ACCESSIBILITY REPORT DEVELOPMENT APPLICATION

**PROPOSED DEVELOPMENT
157-163 CLEVELAND STREET
CHIPPENDALE, NSW.**

9 MARCH 2010

**ACCESSIBILITY REPORT
SCHEMATIC DESIGN**

BASEMENT 1 PLAN
Drawing Number
Amendment
A
DA-02

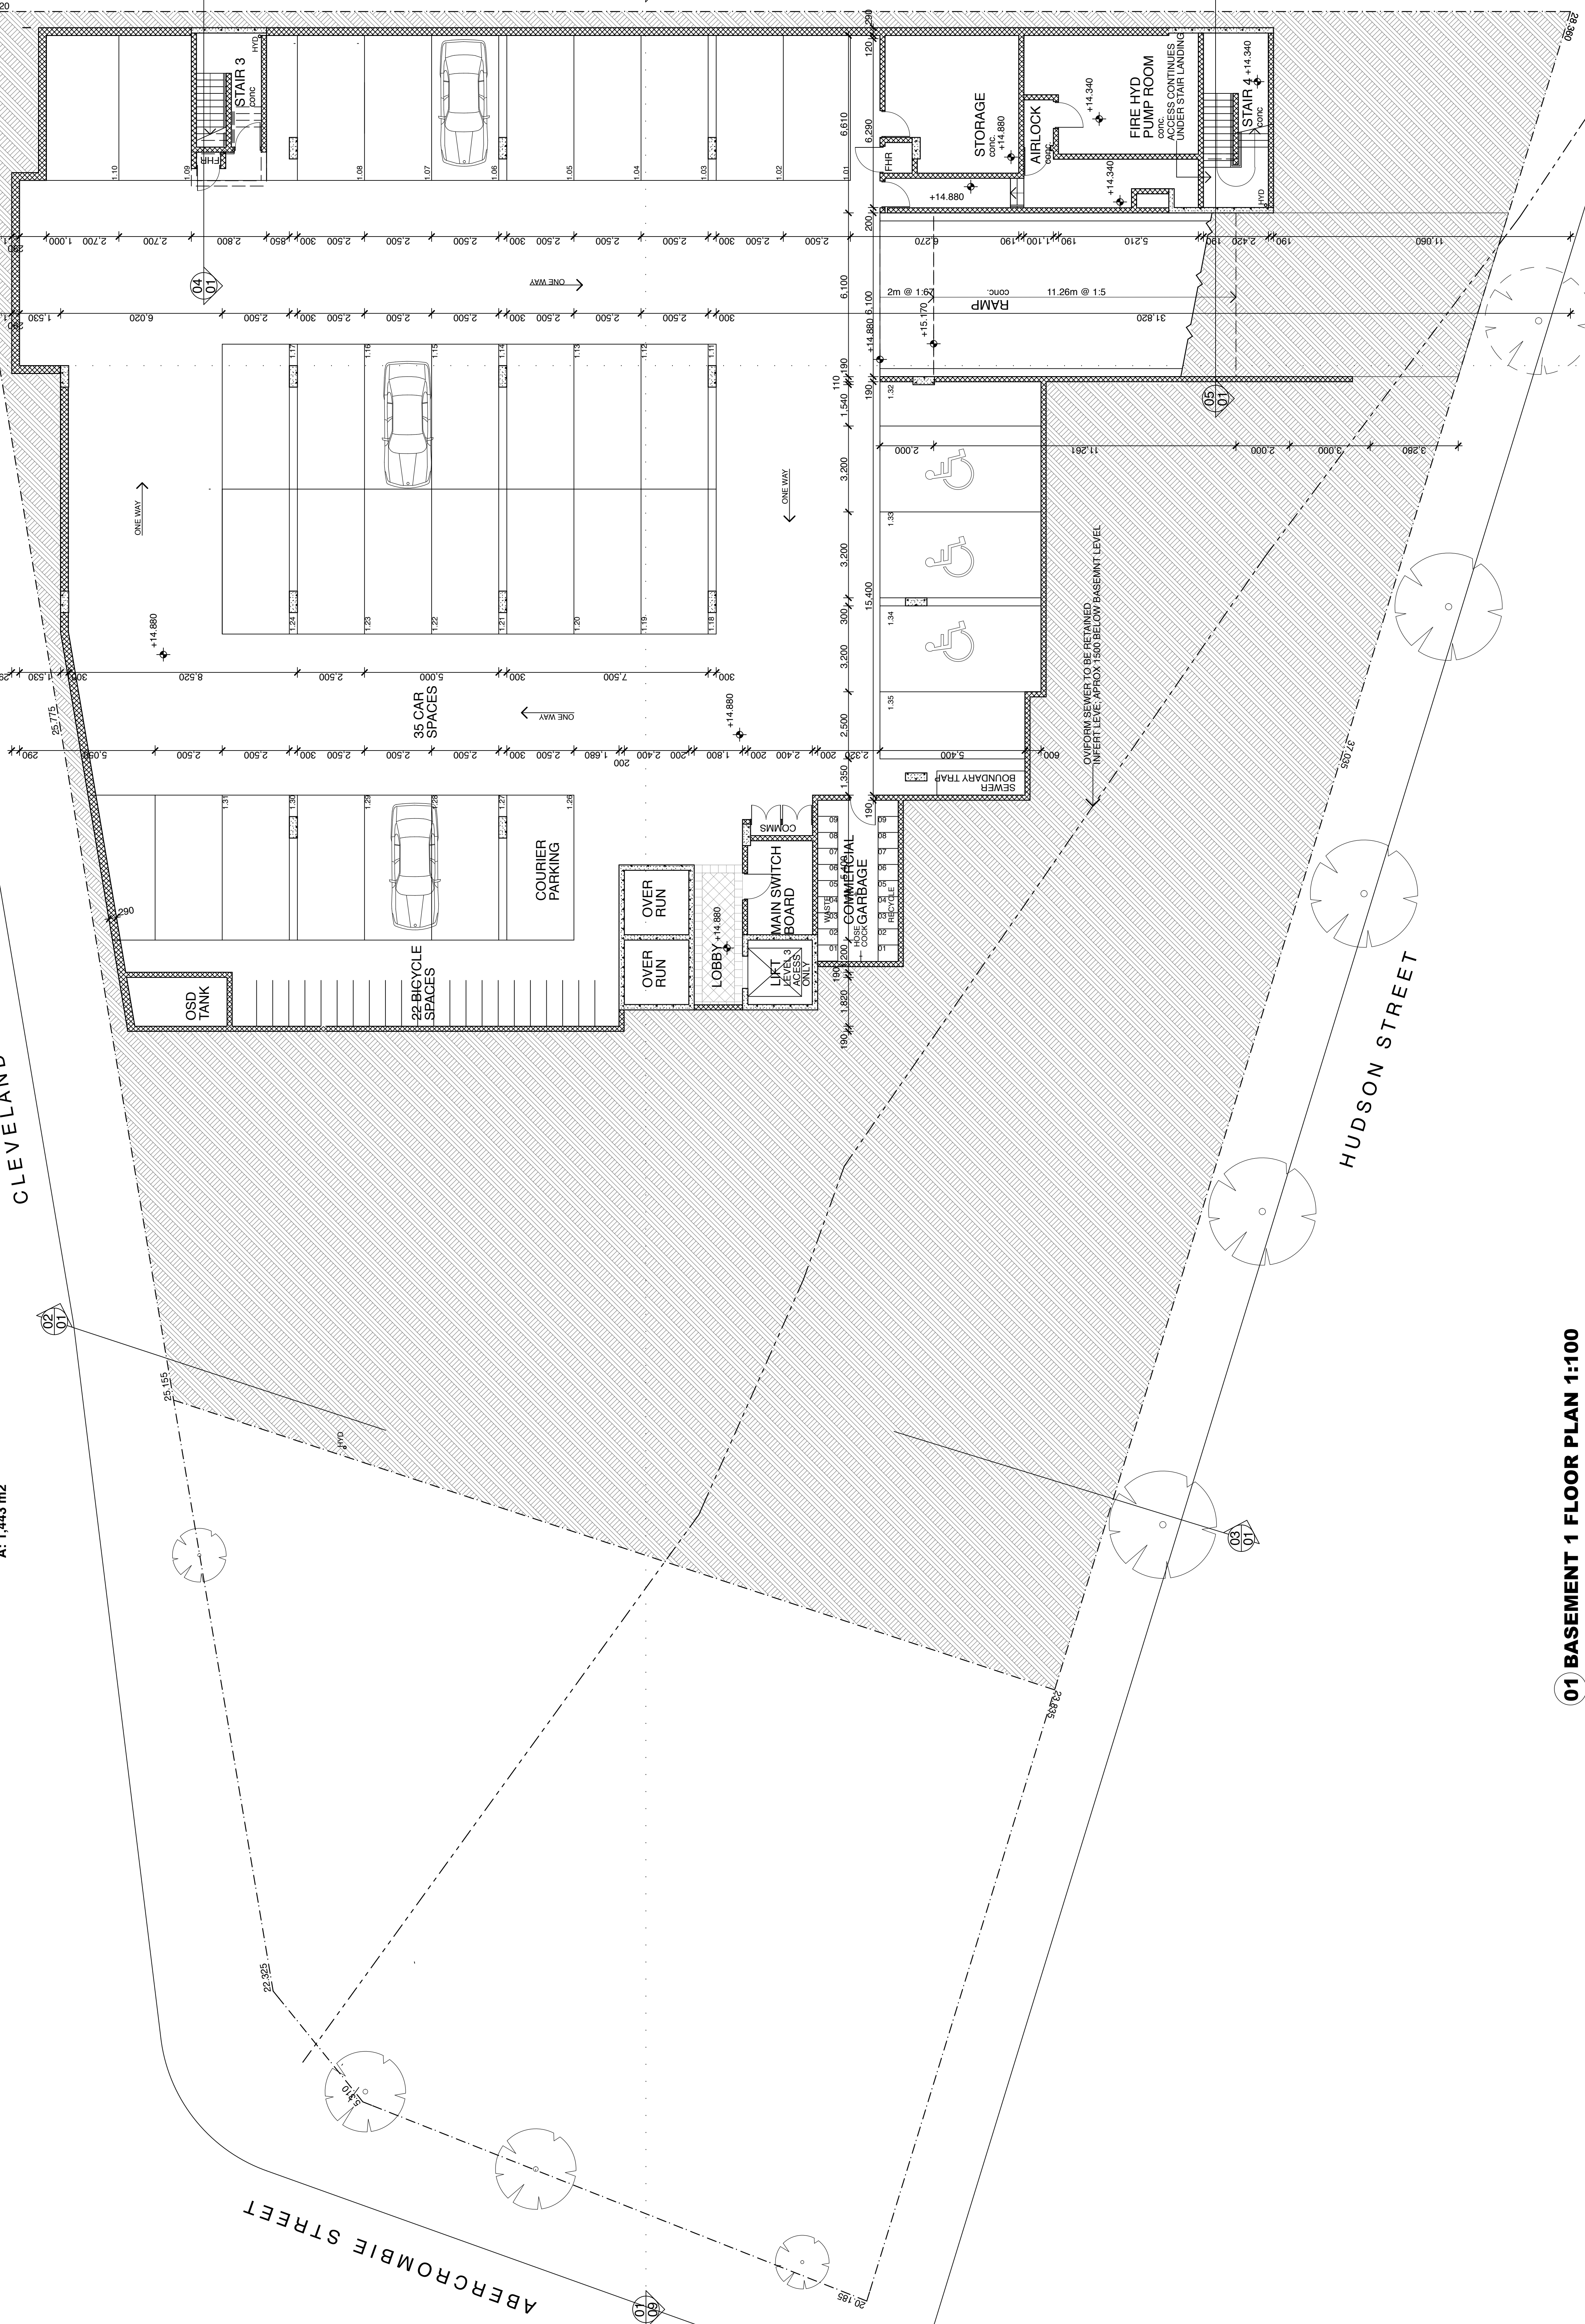
- ~~Eastern parking space does not have a clear 3200mm width.~~
- ~~Confirm car parking numbers comply with BCA D3.5 for both retail and residential.~~

Drawing name
GROUND FLOOR PLAN
AND LANDSCAPE
PLAN

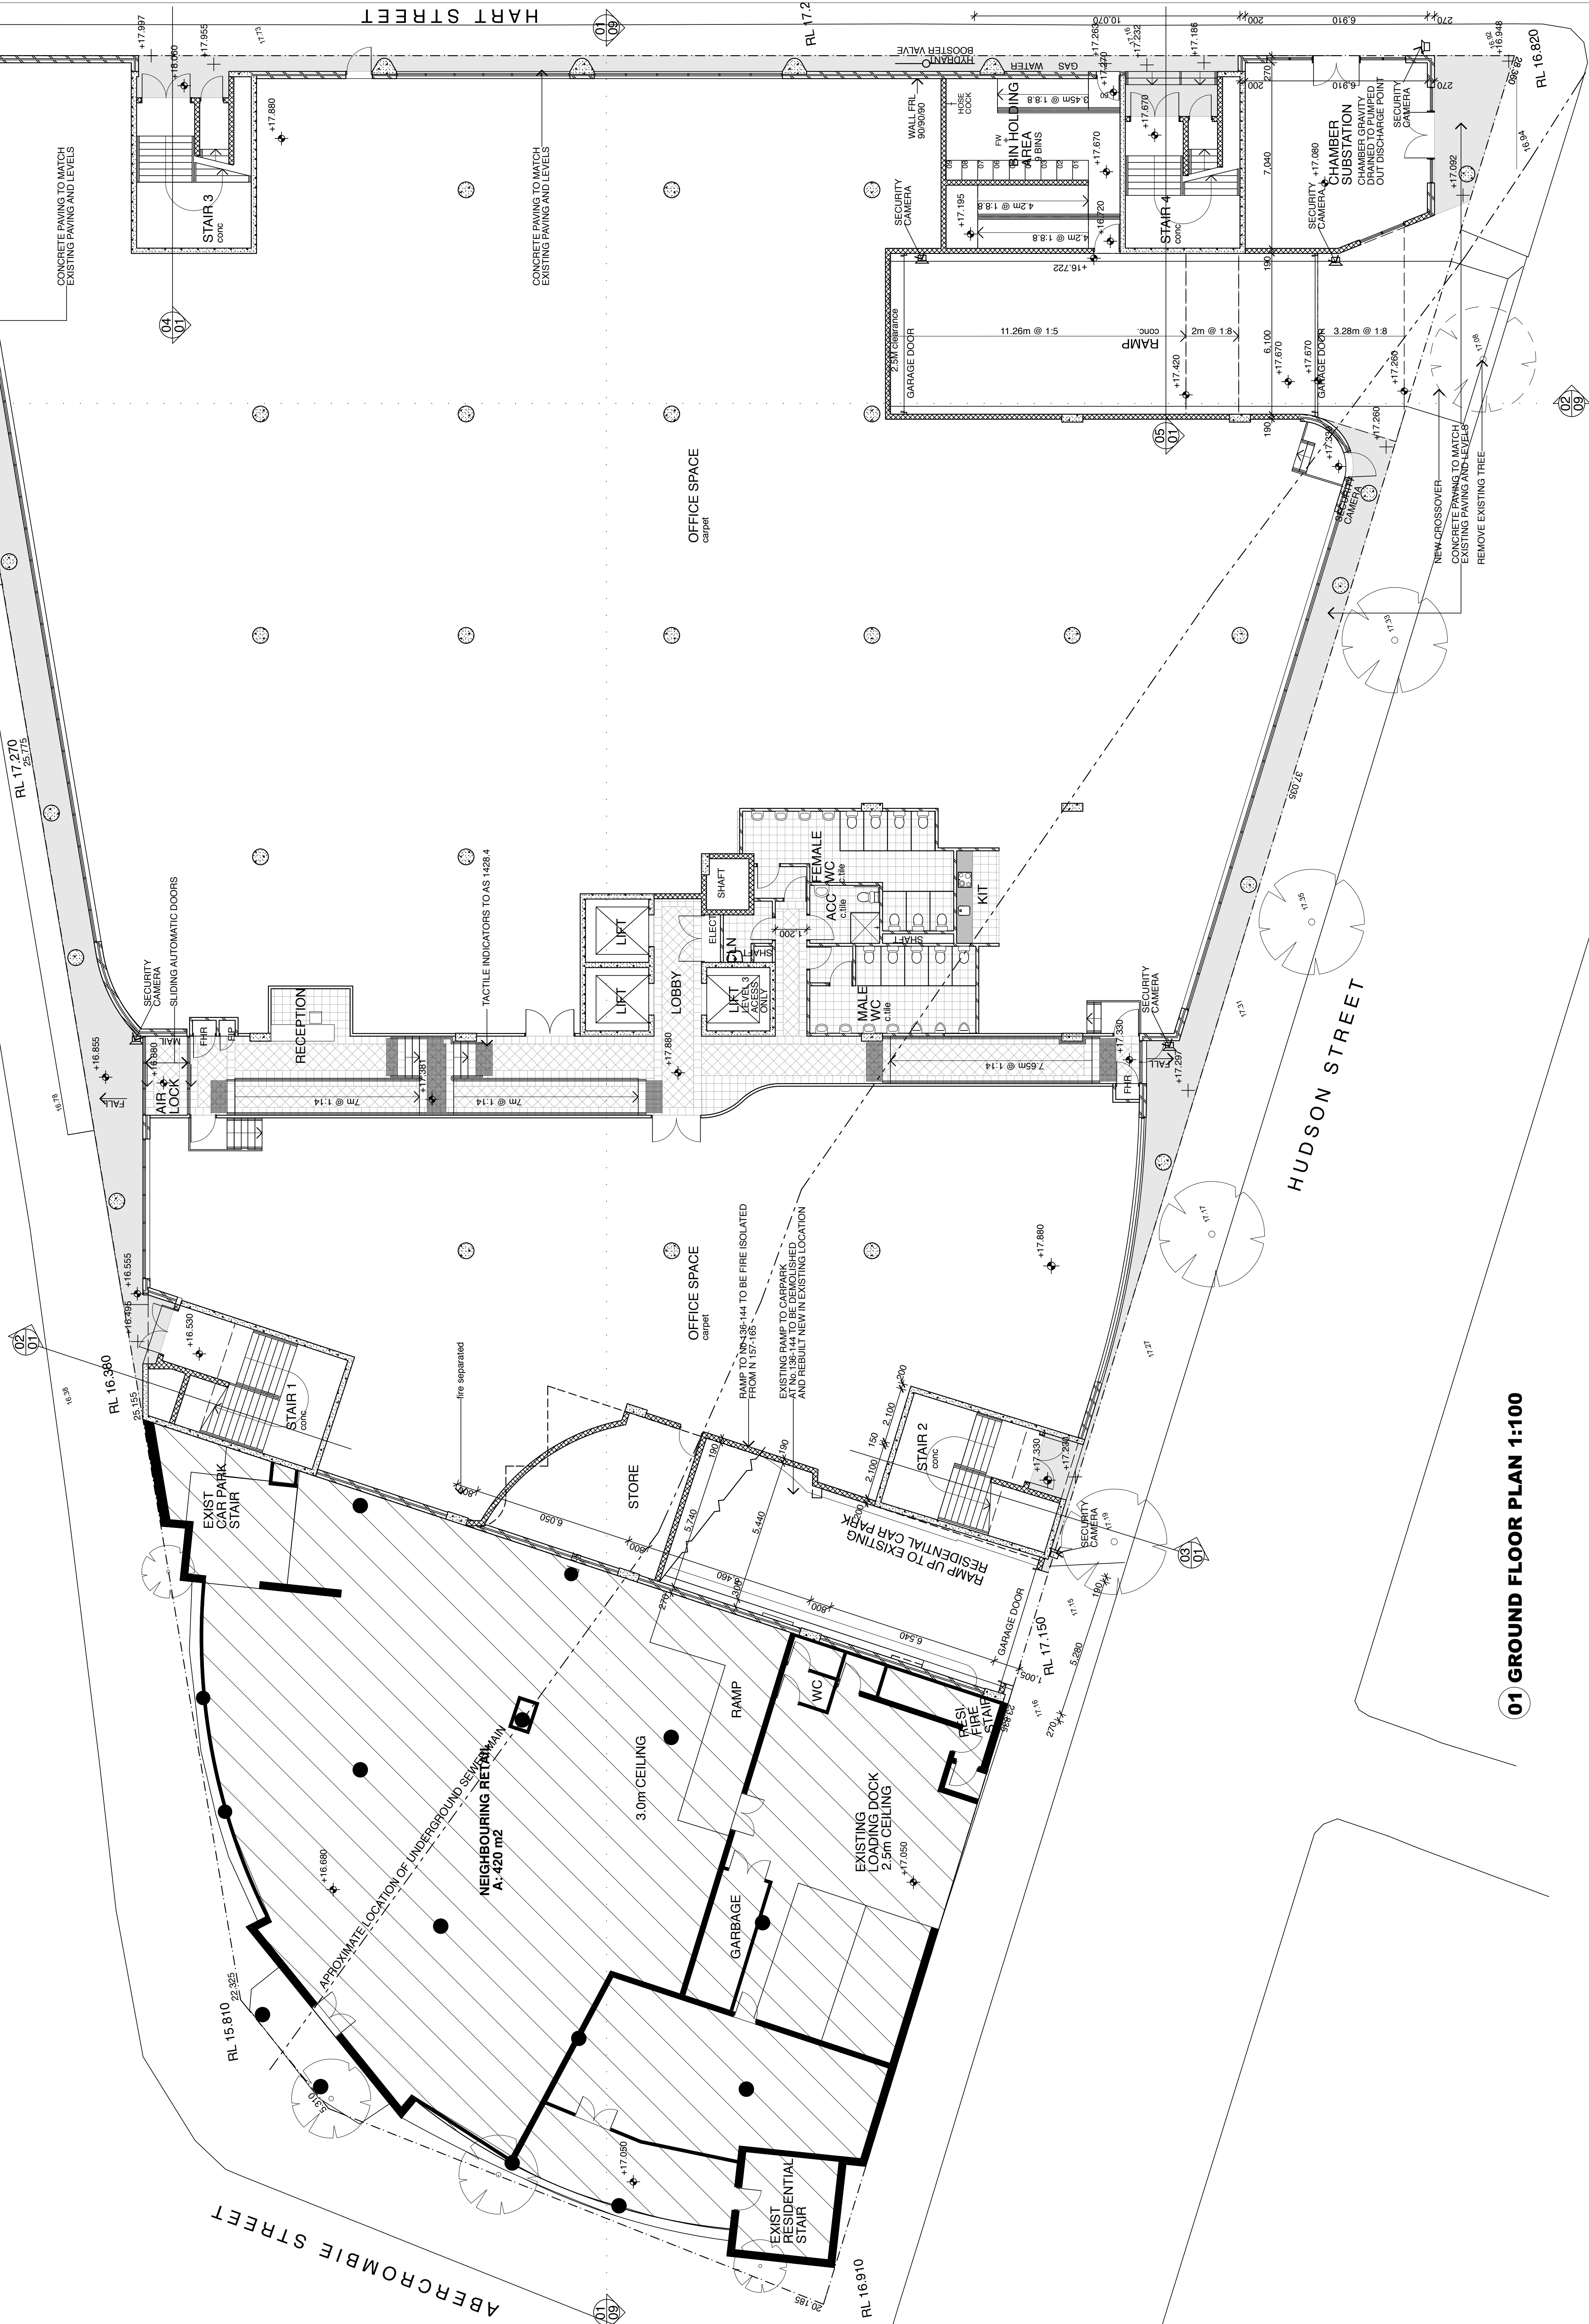
- ~~Northern entry doors including airlock preferably to be automated.~~
- ~~Southern Entry should be fully accessible and include ramp.~~
- ~~Entry stairs to comply with the following~~
 - ~~Handrails to be provided on both sides of the stair in accordance with AS1428.1 part 9.2.~~
 - ~~Handrails to extend top and bottom as detailed in AS1428.1 Fig 17.~~
 - ~~Contrasting stair nosing's to be provided in accordance with AS1428.1 part 11.1.1 (c)~~
 - ~~Handrail profile to be in accordance with AS1428.1 Fig 9.~~
 - ~~Tactile Ground Surface Indicators to be provided in accordance with AS1428.4.~~
- ~~Ramp to be as follows~~
 - ~~Show TGSIs in accordance with AS1428.4~~
 - ~~Show handrails to both sides of ramp in accordance with AS1428.1 5.3(e) with extensions as per fig 1. This will affect the spacing of the ramps.~~

- ~~Reception Desk~~
 - ~~Recommend providing a low height section of counter in accordance with AS1428.2 section 24.1~~

FIRST FLOOR PLAN

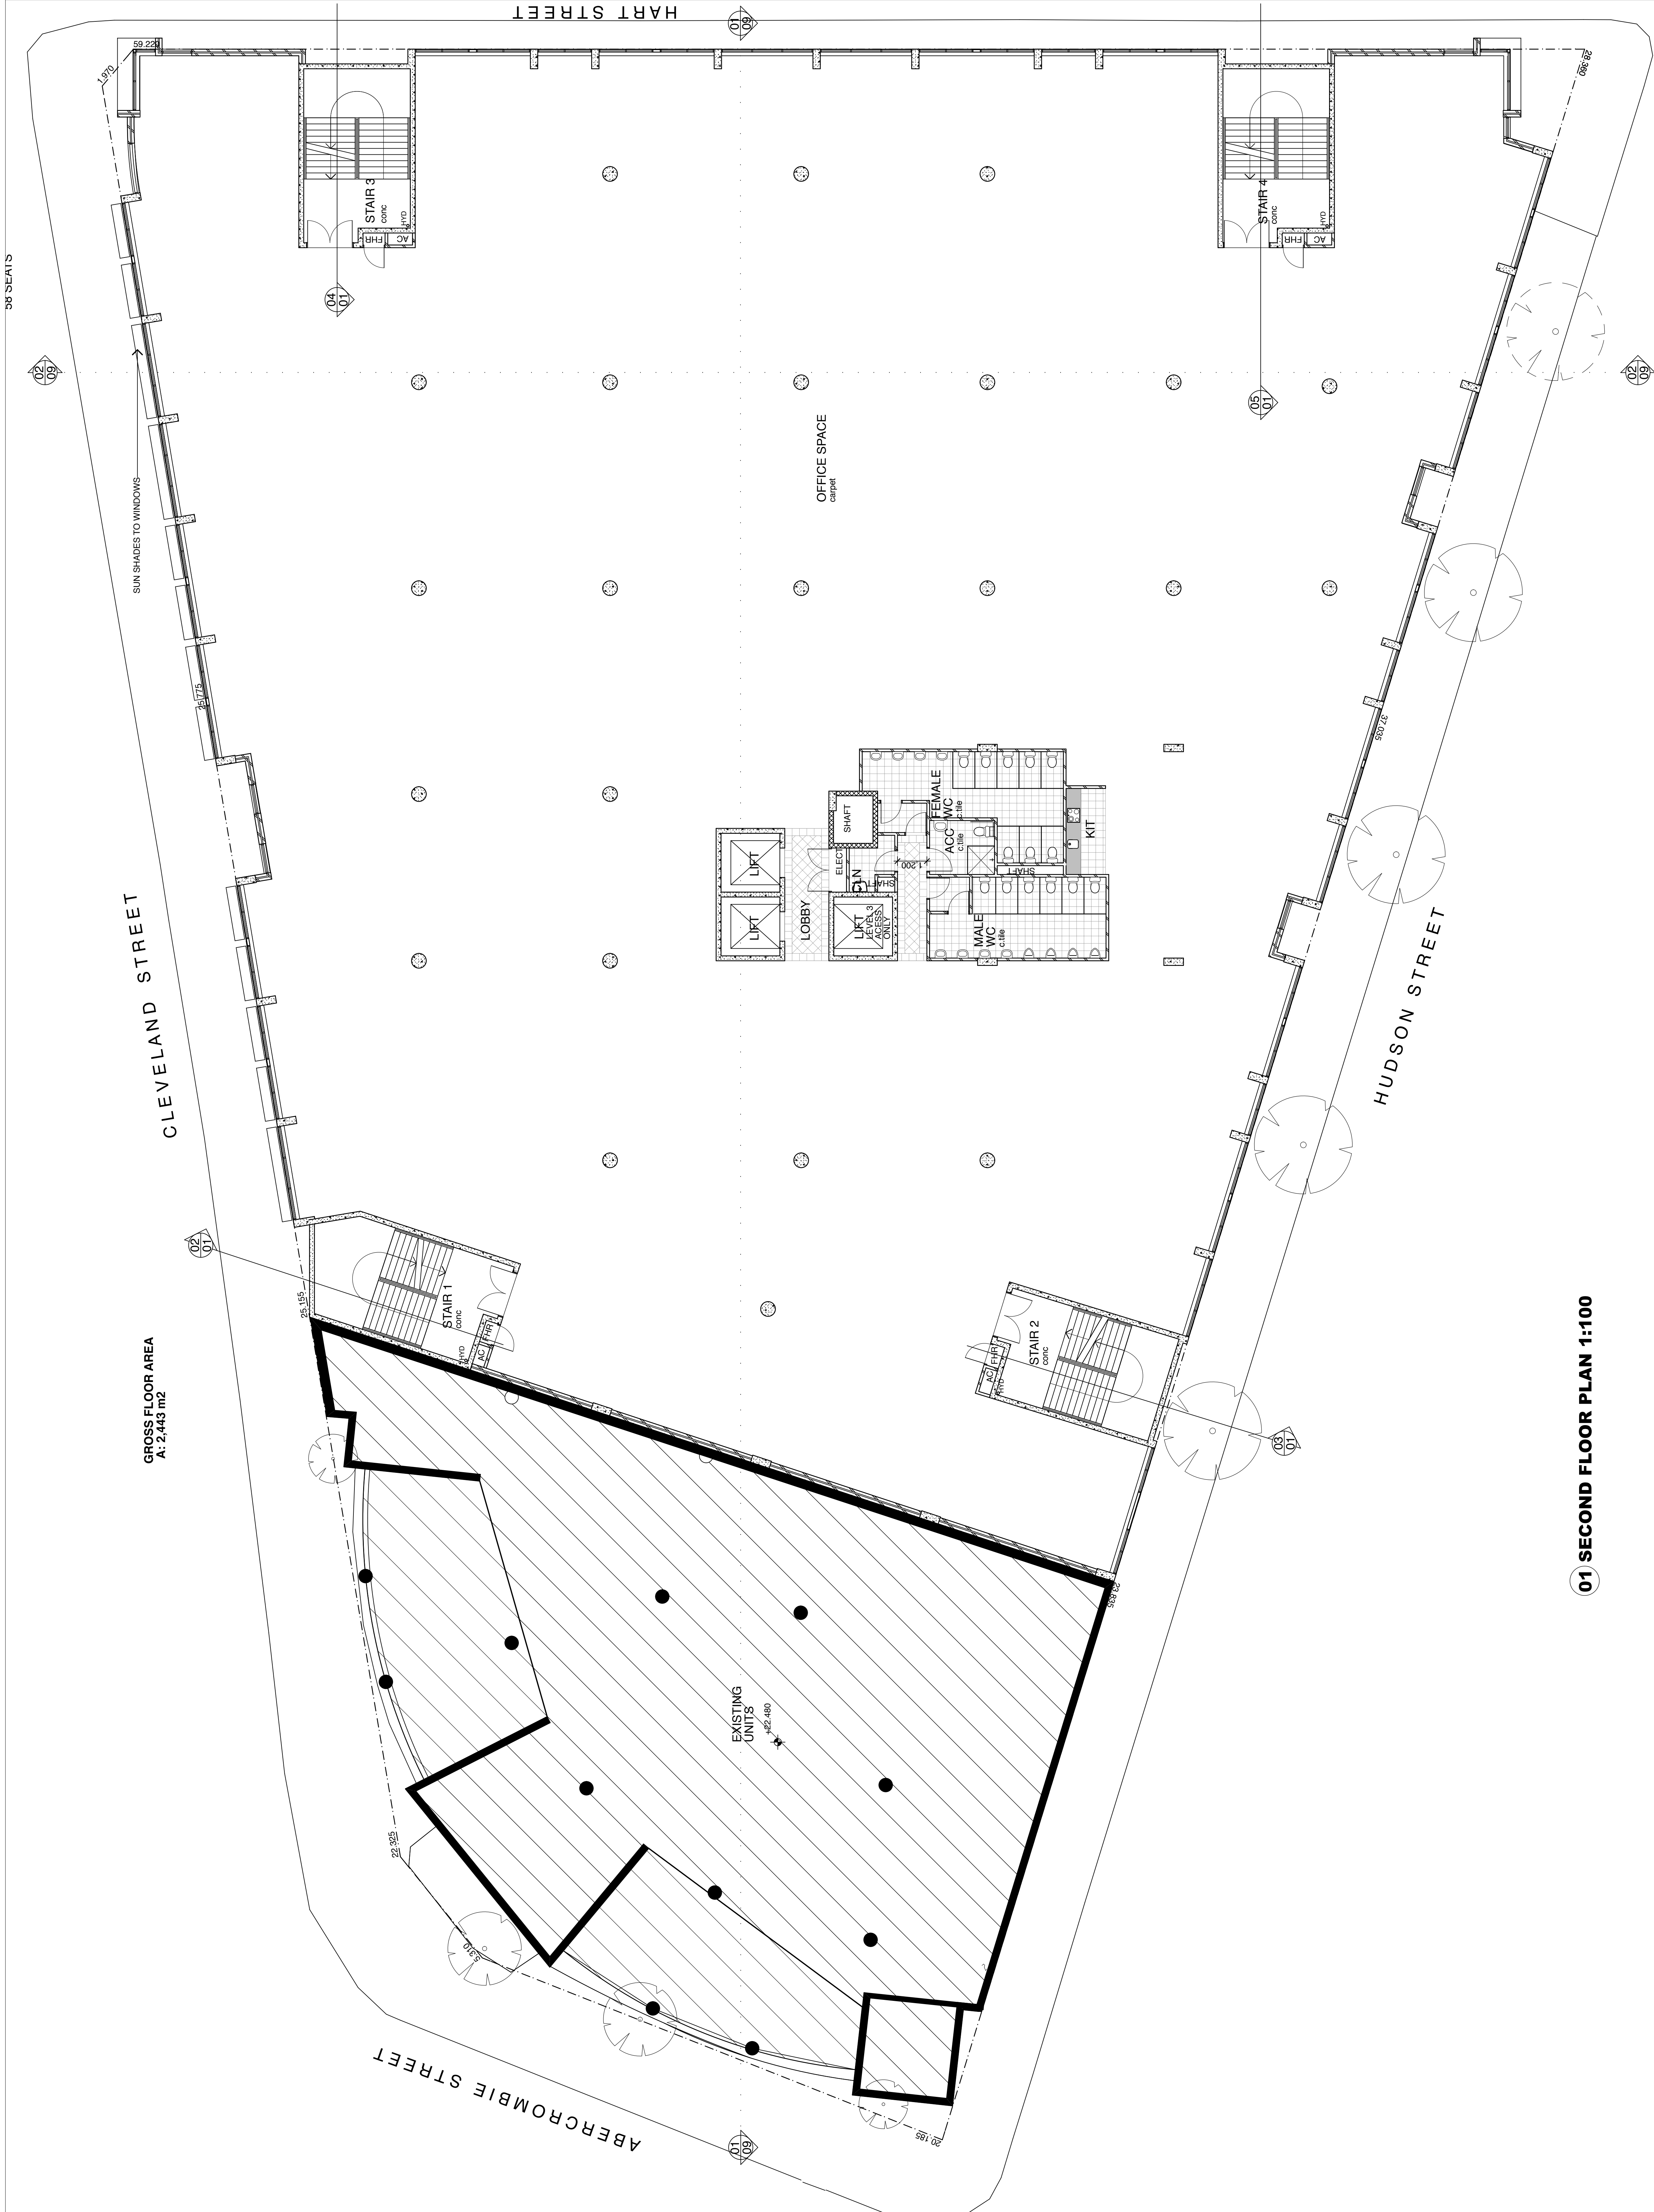
~~No Issues identified~~
